CO-OP MINING COMPANY
P.O. Box 300
Huntington, Utah 84528

UMC 7883.25 Cross-Sections, Maps and Plans

The applicant has not completely addressed this requirement. The following remains incomplete:

FIGURE
NO. 1

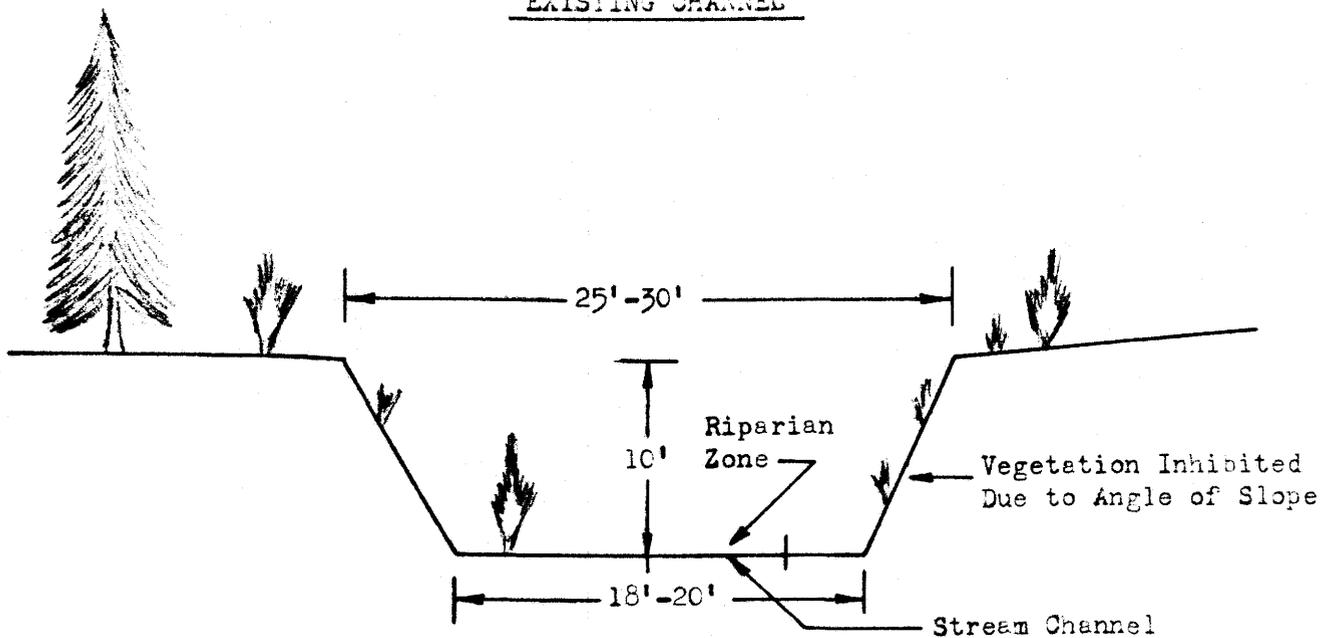
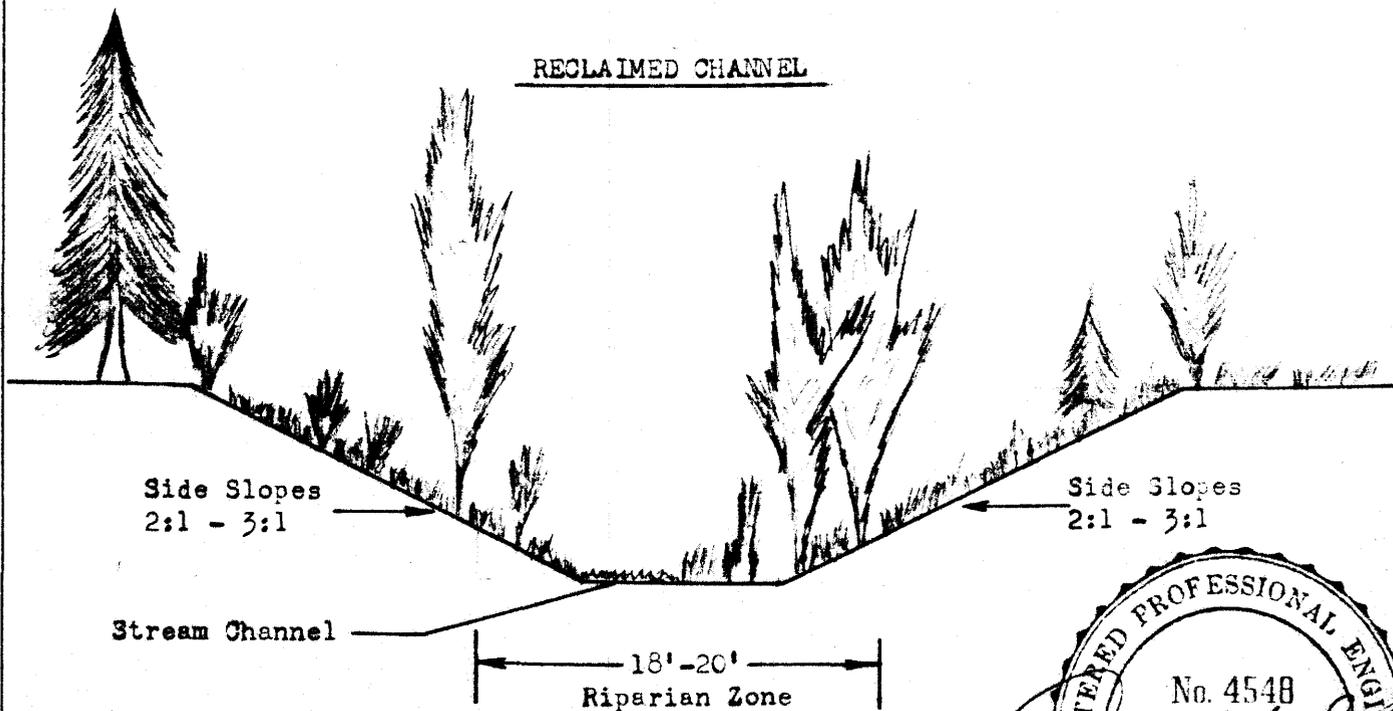
UMC 817.44 Hydrologic Balance: Stream Channel Diversions

1. To use a large track mounted excavator in conjunction with a small backhoe and crawler tractor to remove the 60' culvert and to regrade the opposing banks on approximately a 3 to 1 slope to facilitate revegetation and to enhance the establishment of a riparian zone. (Note fig. 1 for the present stream configuration and projected after reclamation).

BEAR CANYON PLATE 3-2A

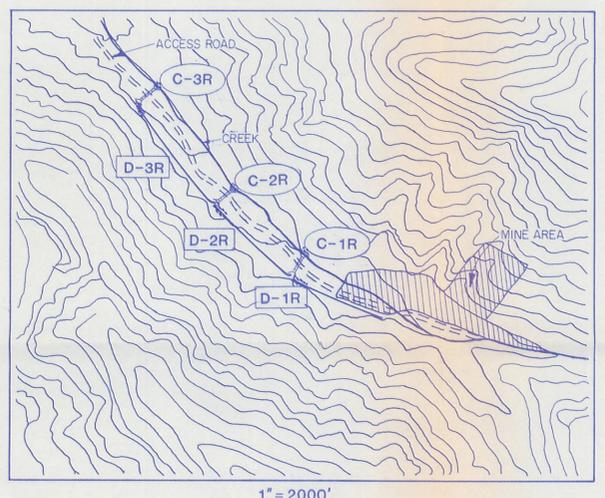
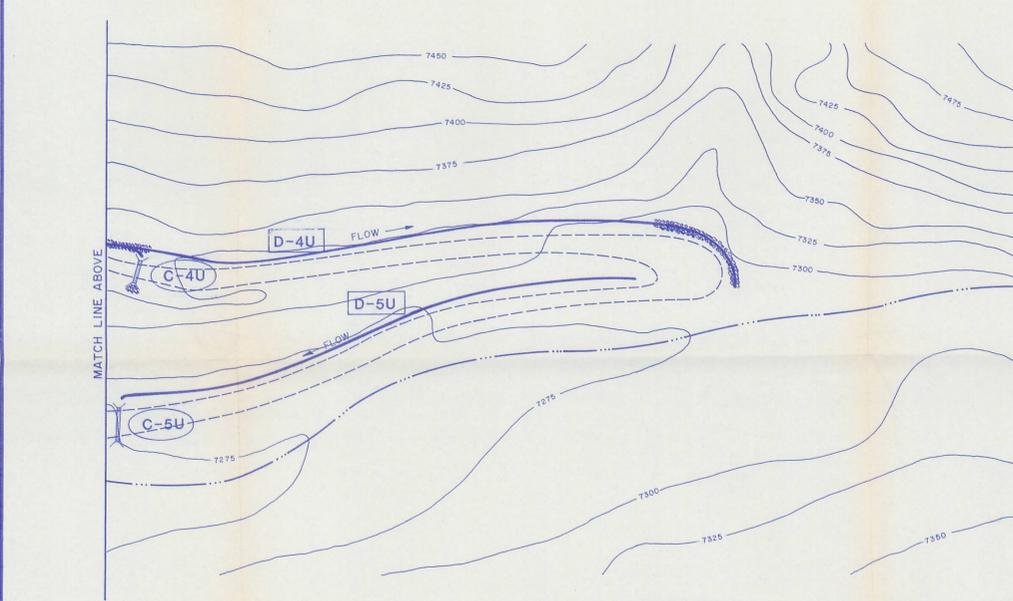
The applicant has not completely addressed this requirement. The applicant has not provided maps, plans and cross-sections to depict postmining drainage patterns. Clarification of a statement in the MRP regarding "horizontal drainage patterns," a postmining drainage map, cross-sections depicting postmining topography and drainage, specific measures for stabilizing reclaimed drainage channels and details on measures proposed for reclamation of the main stream channel where it is currently culverted were not submitted as required. The previous MRP had proposed a log check dam configuration for reclaiming the Bear Canyon stream channel. This proposal was removed by the April 30, 1984 response and the only inference to reclaiming the stream channel is the depiction of eight-inch riprap shown on Plate 3-2.

See Appendix 3-2 and Plate 3-2A
 3-G (Road Reclamation Plan)
 Scale House Approved Modification Letter-
 Approvals end of MRP

Plate 3-2A illustrates the postmining alignment of the stream channels and those areas where additional rip-rap is anticipated.
